A G E N D A

Architectural Review Board

February 22, 2022 – 5:30 p.m.

Project 1: Proposed Addition

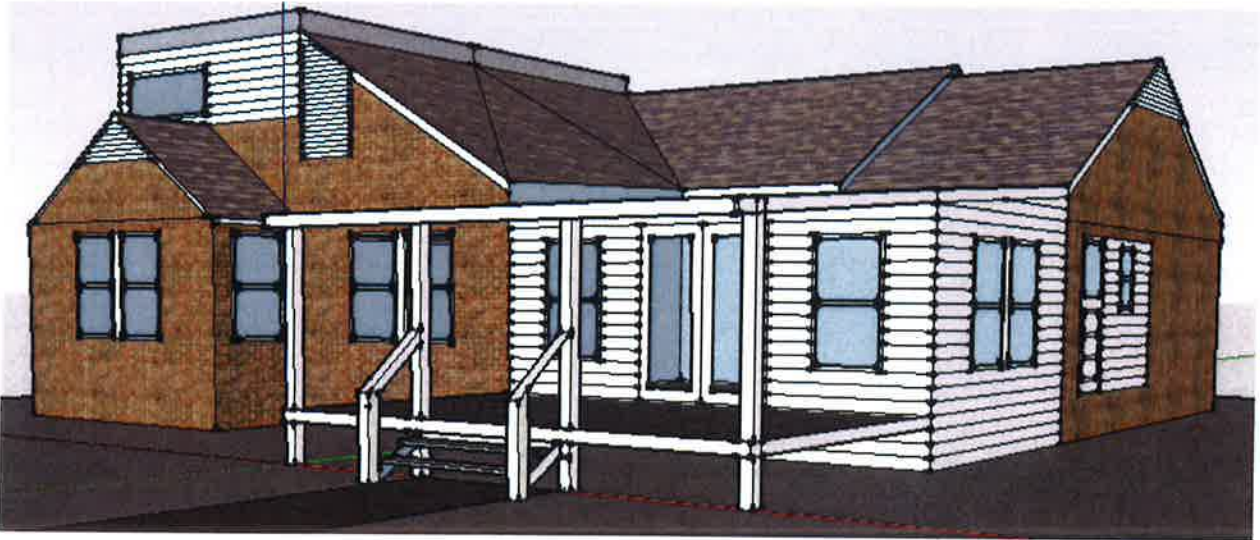
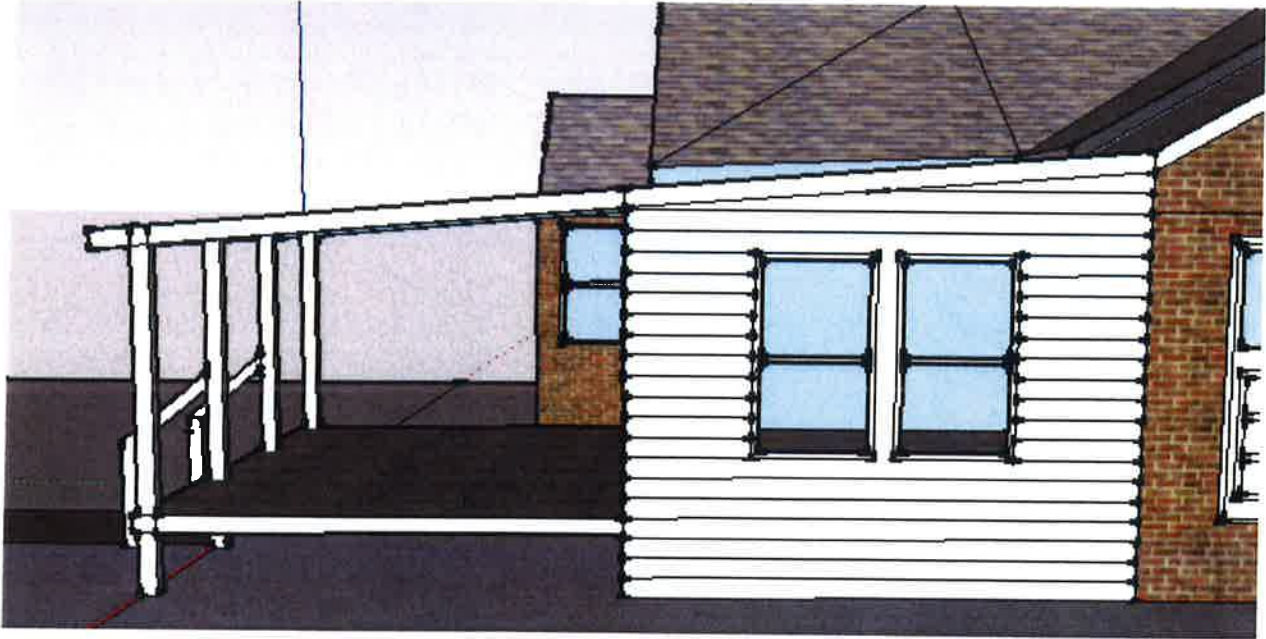
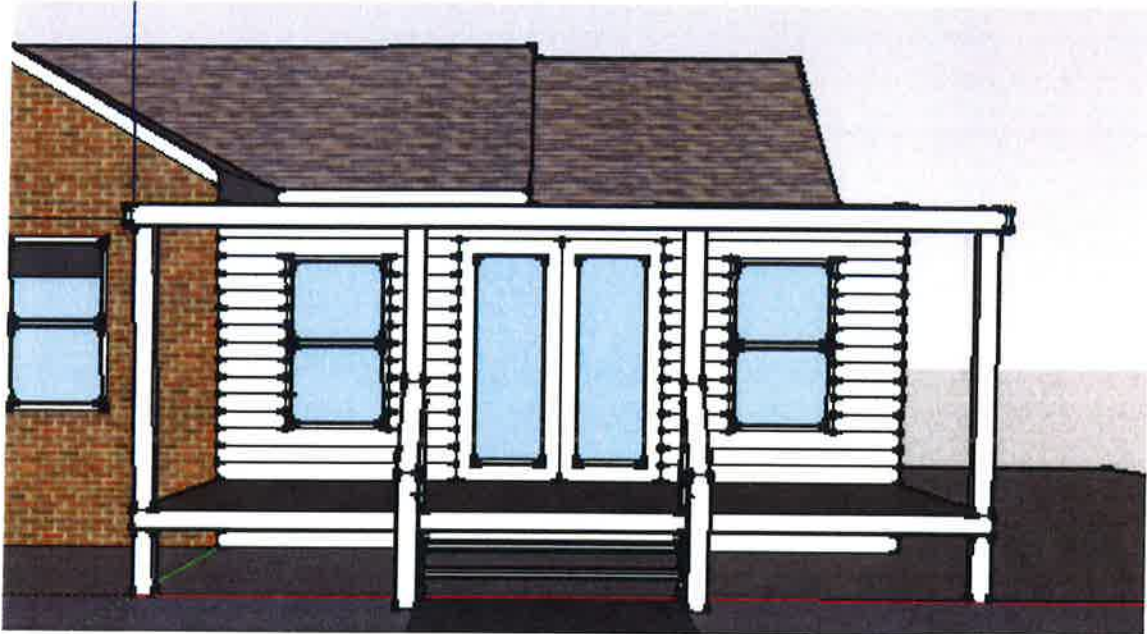
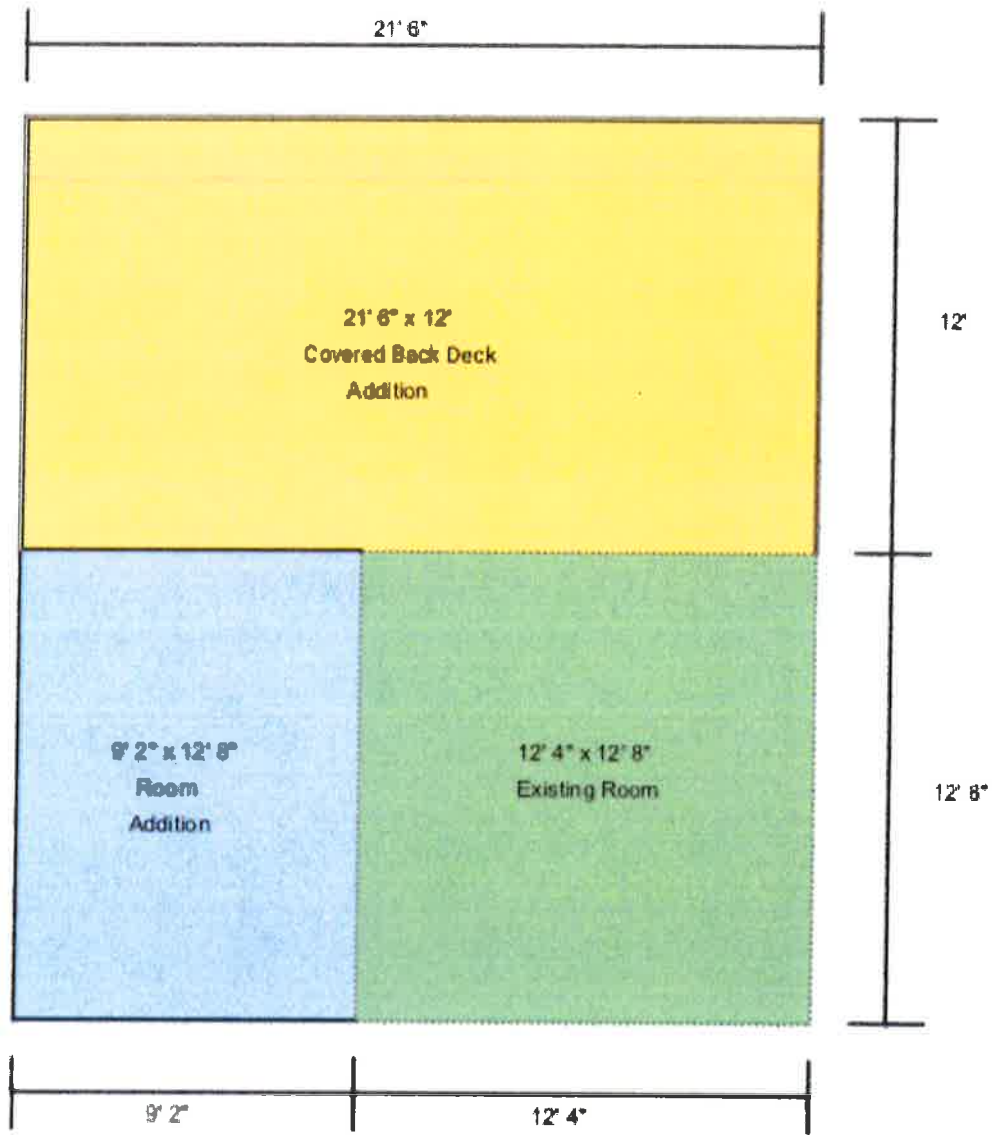
- The Board has approved the use of metal roofing in traditional crimps on low slopes where otherwise a roll roof would be required and on accessory structures.

825 Park Avenue

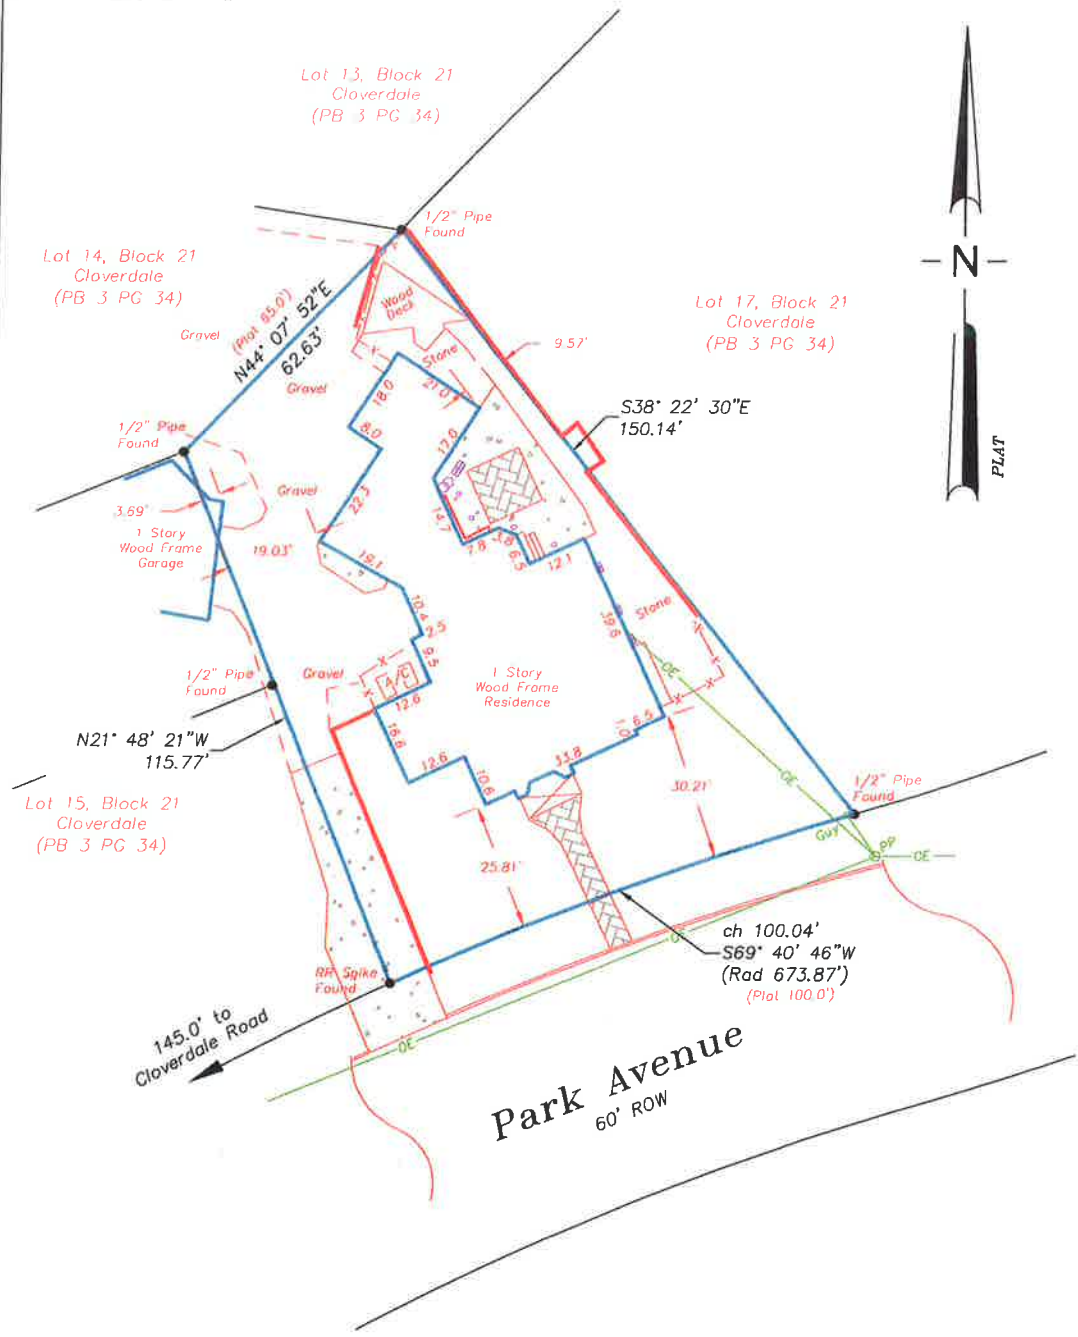
- It appears that if the sketch that was submitted begins at the edge of the driveway, it would encroach beyond the front corner of the house. Based on our mapping system (and not an on the ground measurement), there appears to be 23' from the corner of the house to the edge of the driveway. Staff recommends that the pad, if approved, encroach no further into the front lawn than the corner of the house.
- Front parking areas have been approved with screening landscaping to help soften the appearance of the new pavement. At the minimum, there should be a green buffer along the edge of the pad that runs parallel to the street. If this area is within the right of way, the plant selection will also require approval from the urban forester.
